Site Specific Management Plan 0011- [sector 560-570]  
MacKays to Peka Peka Expressway

23 NOVEMBER 2015 - REV C - CERTIFIED ISSUE

## SITE SPECIFIC MANAGEMENT PLAN PEKA PEKA NORTH [SSMP11 – SECTORS 560-570]

Title: SSMP 11 [560-570] - SHEET 17  
LIGHTING PLAN

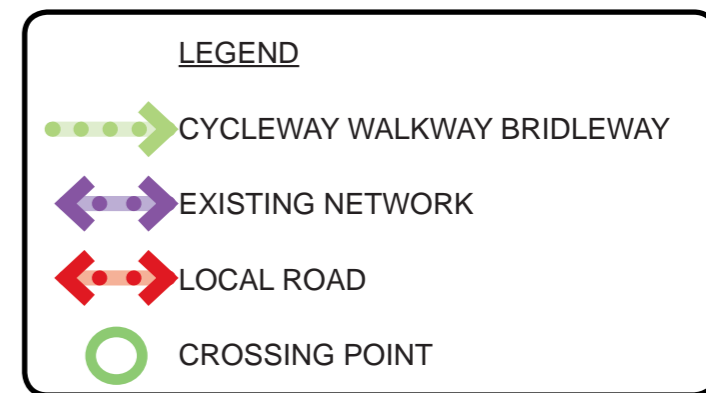
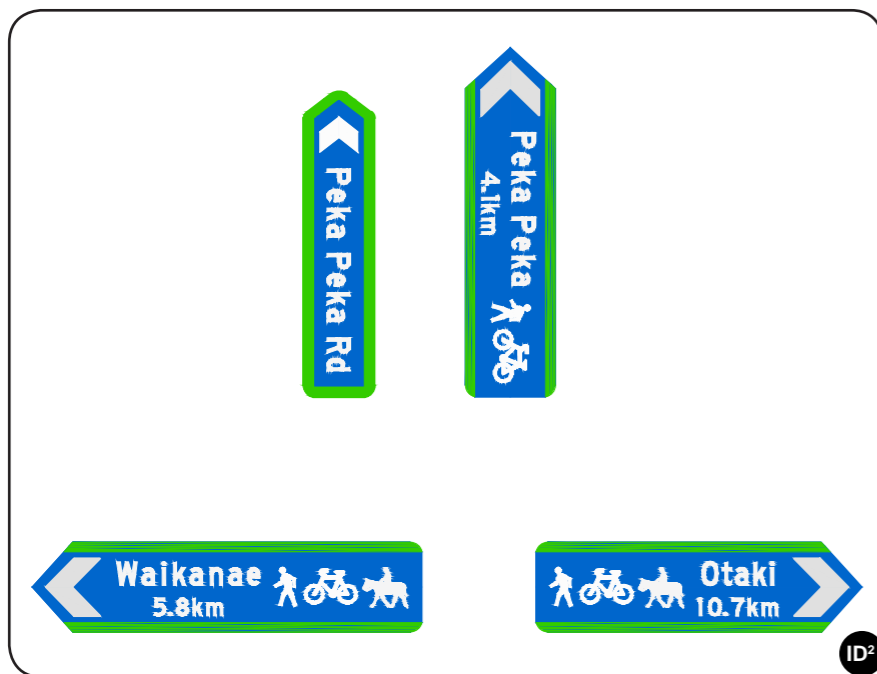
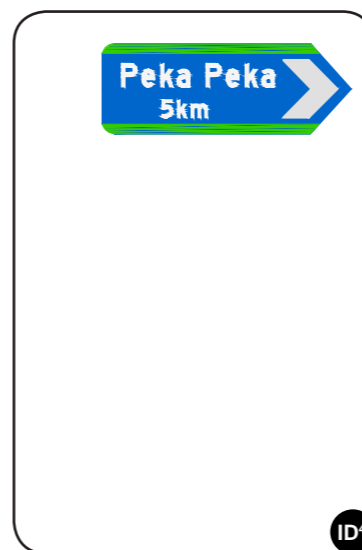
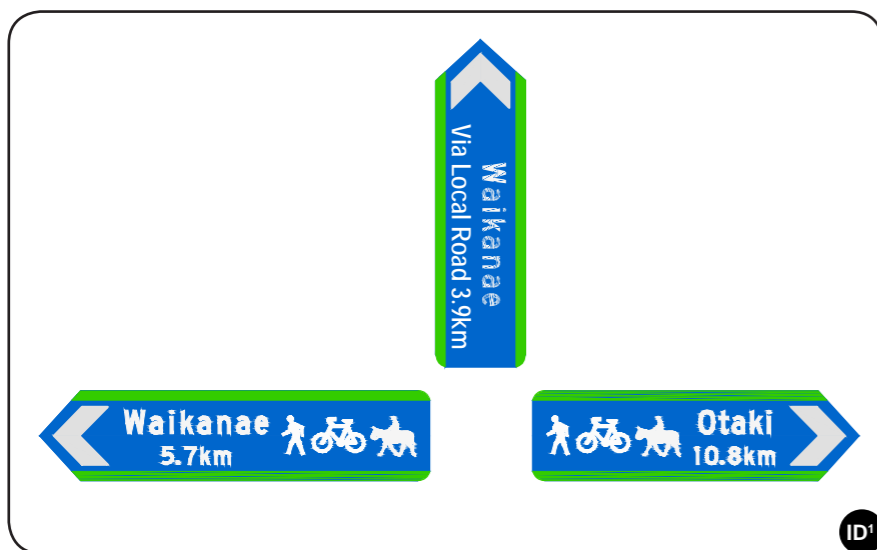
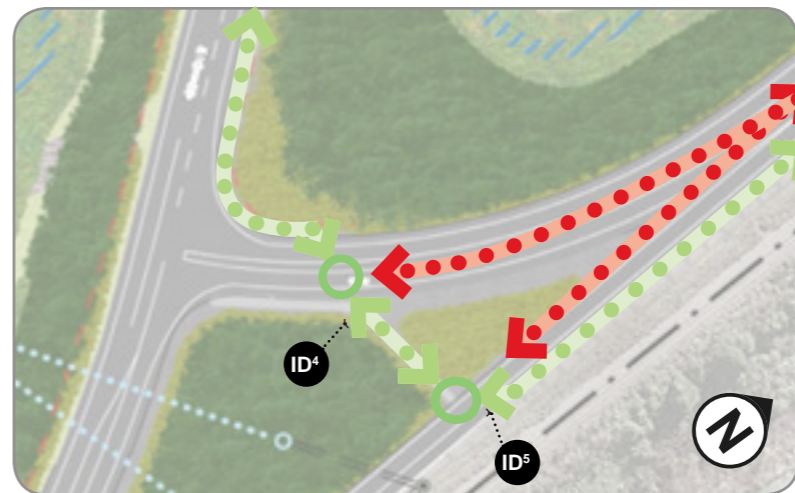
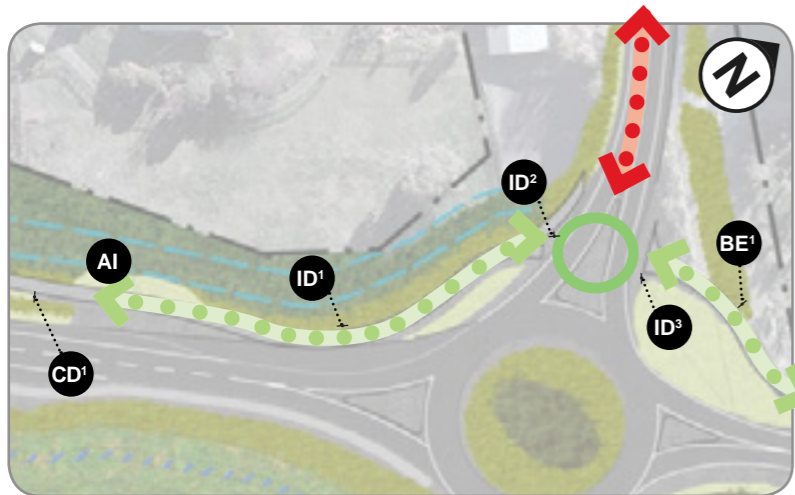
JW	No indication whether there will be a pole light at the intersection of the CWB with Te Kowhai Road.	Appendix 1 Sheet 17	The base plan for Sheet 17 (M2PP-121-D-DWG-8704) was incorrect (it showed the previous plans base). This has been corrected. A road light on the corner of Te Kowhai link road and Te Kowhai road will provide light to the intersection.
		JP	Sheet 17 DWG 8704 seems misaligned	See Above	See Above
		JP	Absence of lighting over a section of Peka Peka Link road.	Appendix 1 Sheets 14-17	Ducting for further lighting has been provided, however currently lighting the full length of the road is not considered necessary.
		JP	Unsure of intention off ID3 signing cycle traffic to SH1.	Appendix 1 Sheet 19	Following the completion of PP2O this signage will need to be adjusted, however in the interim cycle traffic heading northbound will need to use the on-ramp to join SH1.

Title: SSMP 11 [560-570] - SHEET 19  
CWBS SIGNS AND LOCATIONS

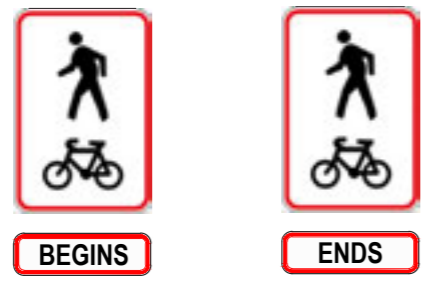
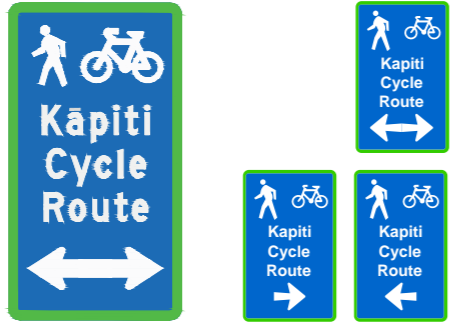
JW	Additional Directional sign required at Te Kowhai Road.	Appendix 1 Sheet 19	Following the completion of PP2O directional signage will likely be necessary here. However the design of this signage is best left until the design of PP2O has been resolved. In the interim signage beyond the local road signage has been deemed unnecessary as it is a no-exit street with less than 20 residences.
		JW	Suggestion that an additional sign will be necessary at the corner of Peka Peka Link Road and Hadfield Link Road to direct people from existing SH1 to CWB.	Appendix 1 Sheet 19	Directional signs are now shown at both the crossing point of Hadfield Link Road and that of the slip lane to SH1.
		JW	Vegetation to be retained plans Revised plans yet to be signed off since change in link road alignment. This is contrary to the statement on page 10.	5.A Page 10	This statement has been amended to reflect that the plans have been amended with the shifted link road alignment and that changes made since are to be considered as a part of the review of this SSMP.

1. ELEVATION - APPROVED - PEKA PEKA ROAD BRIDGE EAST ELEVATION - 1:250@A3

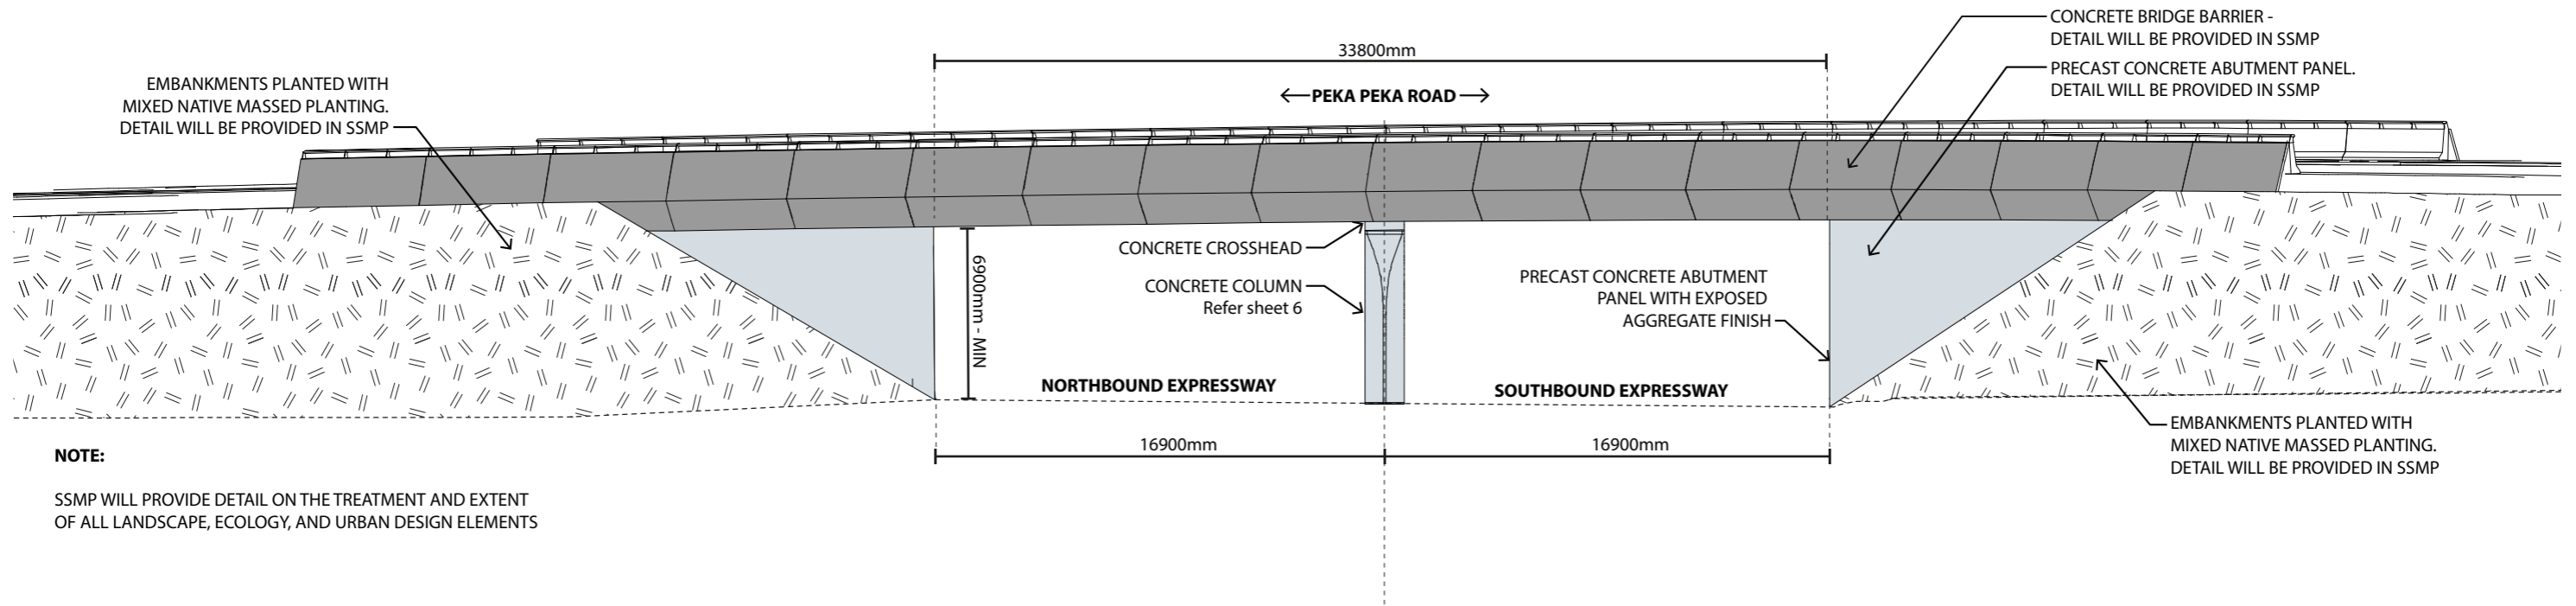
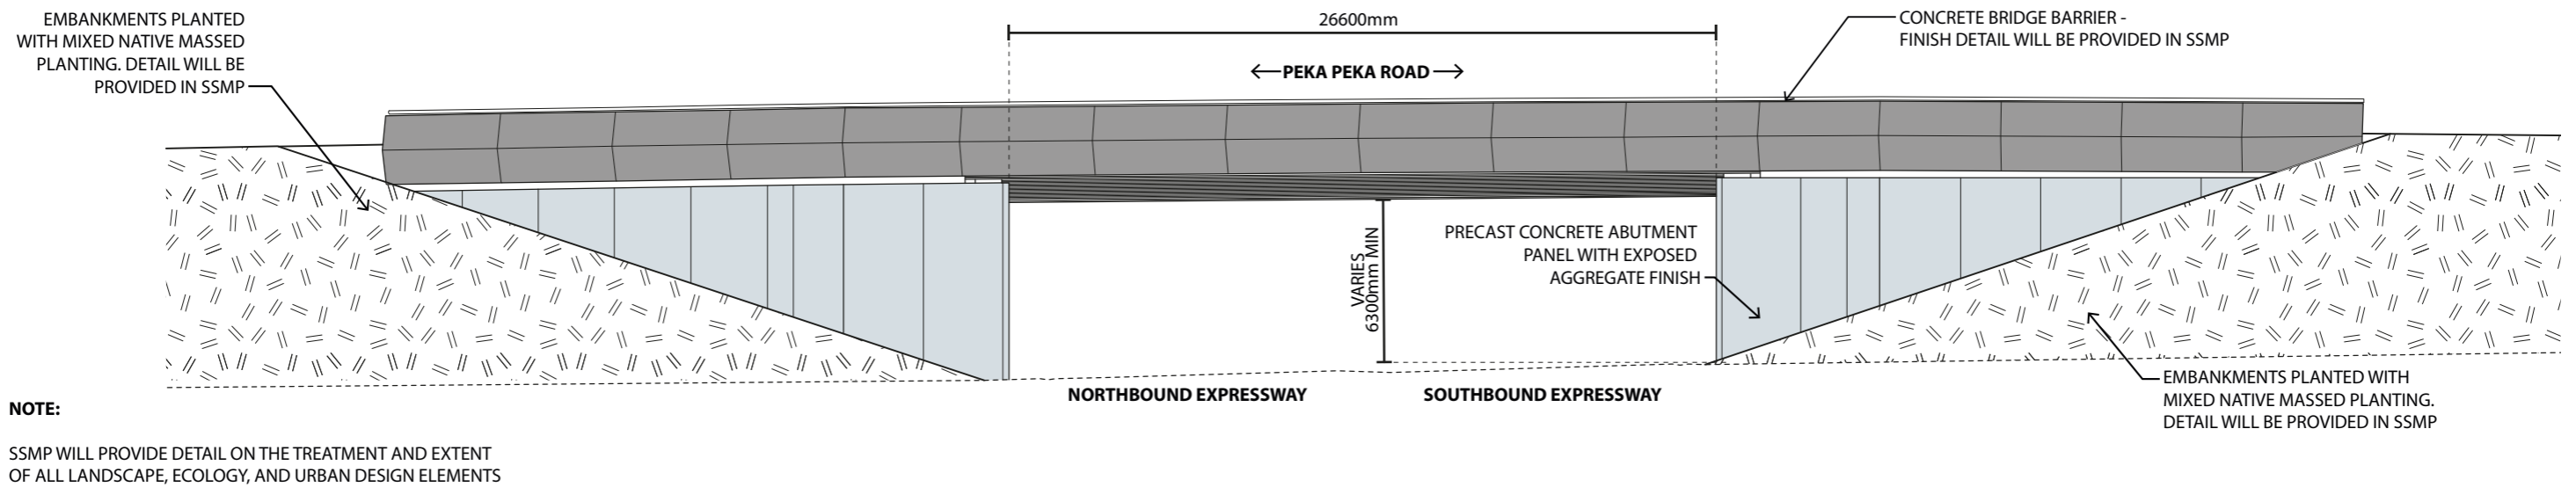
| 1. Reduced overall length of the bridge, reduced number of spans from 2 to 1. | 3. Columns removed   |

| 2. The realignment of the local road helps to reduce the skew of the bridge abutment panels                            | 4. Peka Peka link road has been realigned to reduce the skew angle and span length of the bridge. |

1. SECTIONAL ELEVATION - APPROVED - PEKA PEKA ROAD BRIDGE NORTH ABUTMENT - 1:200@A3

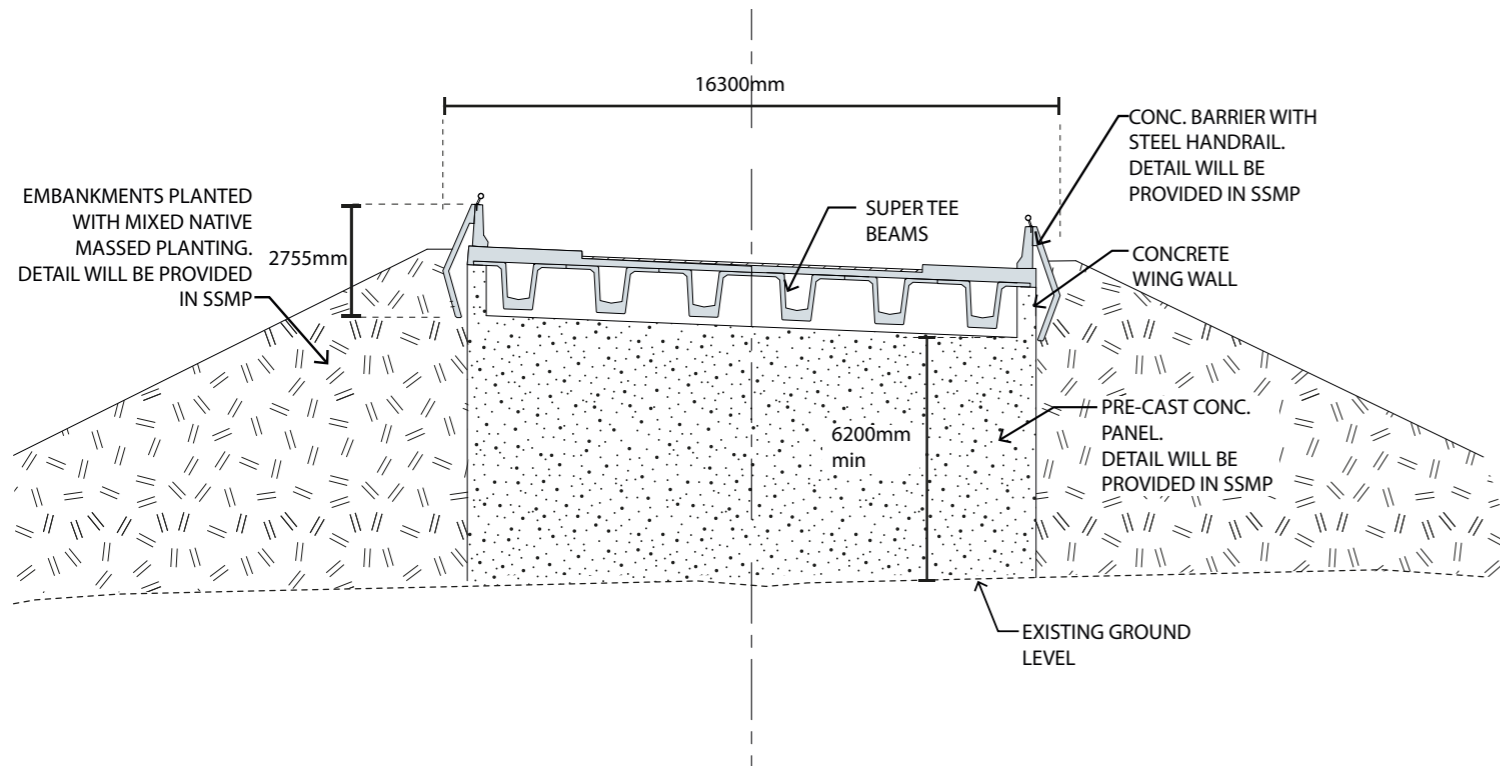
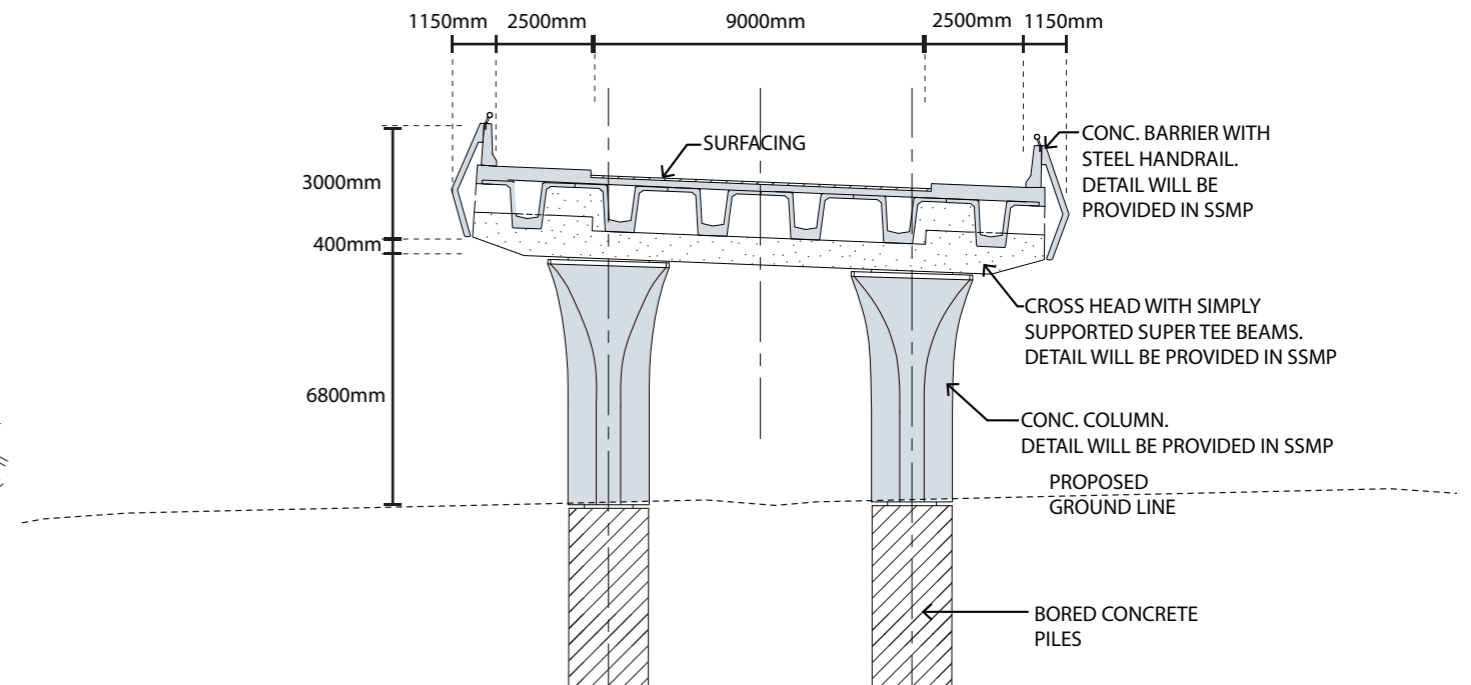
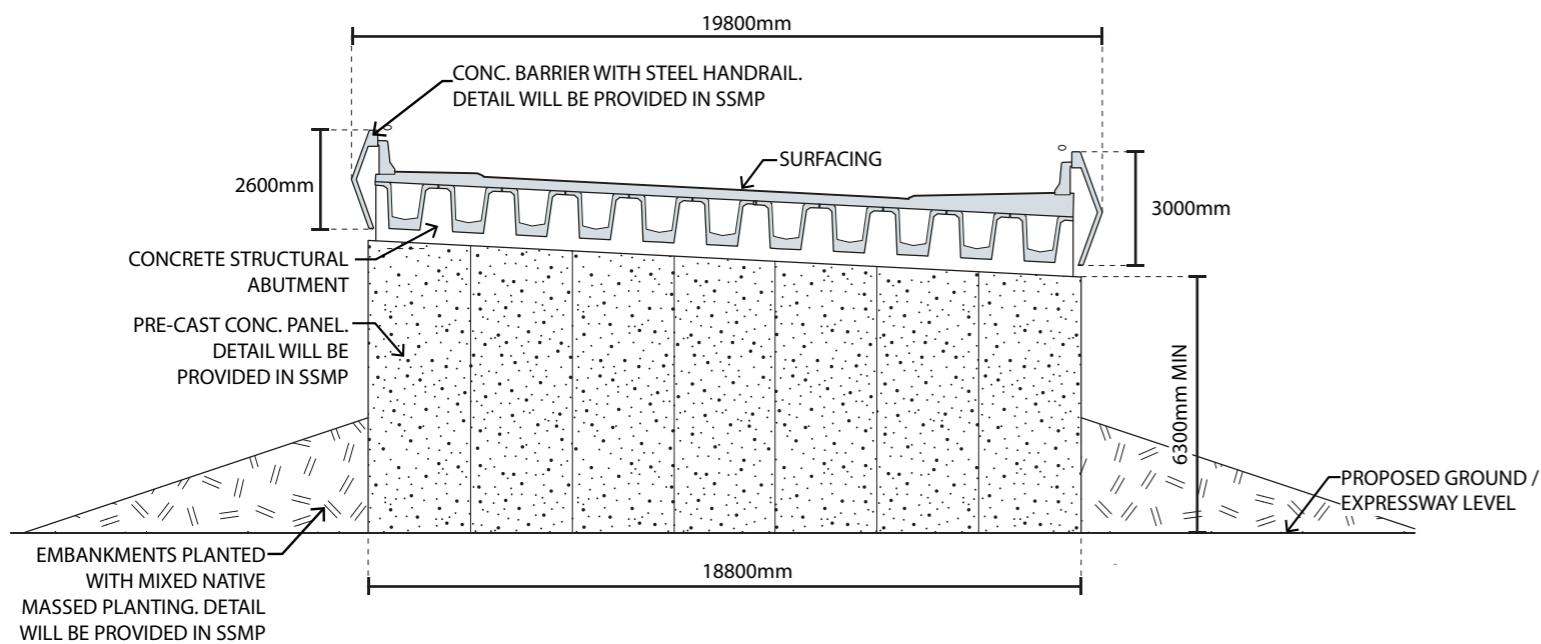
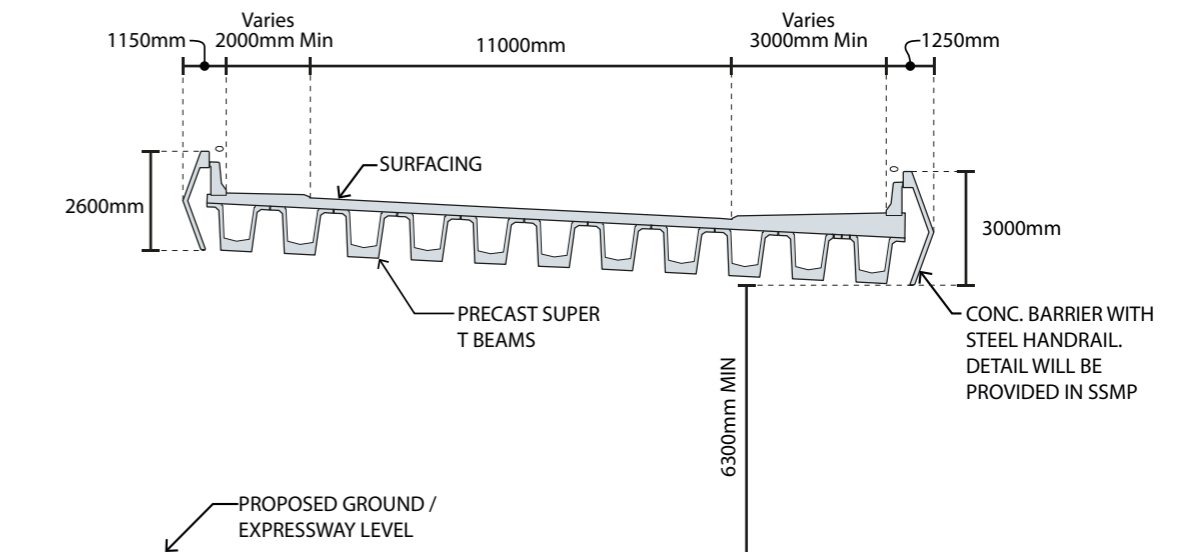
1. Reduced span length of the bridge, reduced number of spans from 2 to 1.
2. Columns removed

3. Increase to the size of the concrete bridge barrier/ fascia panel.

3. Change to bridge deck thickness on the southern side. Increased barrier size better conceals the underside of bridge
